Product Change Notification

Date Issued :	September 04, 2024	PCN Number :	515835
Reason for Change :	Change to Product		
Description of Change :	This notification is to inform you about changes that are being made to the part(s) as identified in the list. This change will not affect the Fit, Form, Function, or appearance of the parts. Or it may result in a change to the specification or raw material.		
Assessment of Change :	Reliability Test Report/s		
Planned Implementation Date :	March 04, 2025		
Customer Sample Availability Date:	September 10, 2024		
Last date to request Samples by Customer : September 10, 2024			
Please note if Samples are not requested as per Customer Samples Request date, it may take additional 4-6 weeks to arrange Samples.			
Traceability Code Markings / Date :	Date code

2156740051 Revision A

Before Picture

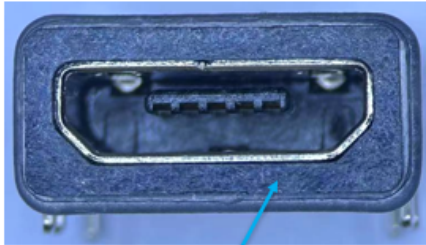
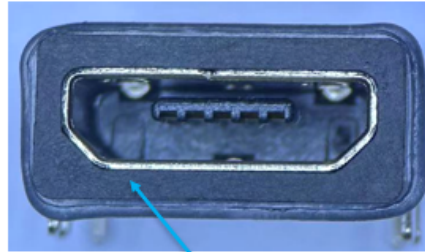
- No obvious different for part appearance.

Before: LCP for housing

After: PA10T for housing

- Change housing material from LCP to PA10T for improving product performance and quality.
- Product Impact
 - No impact to fit, form or function
- Part Number Impact
 - 2049261103; 2049261104;
- FAI & Test report are OK.
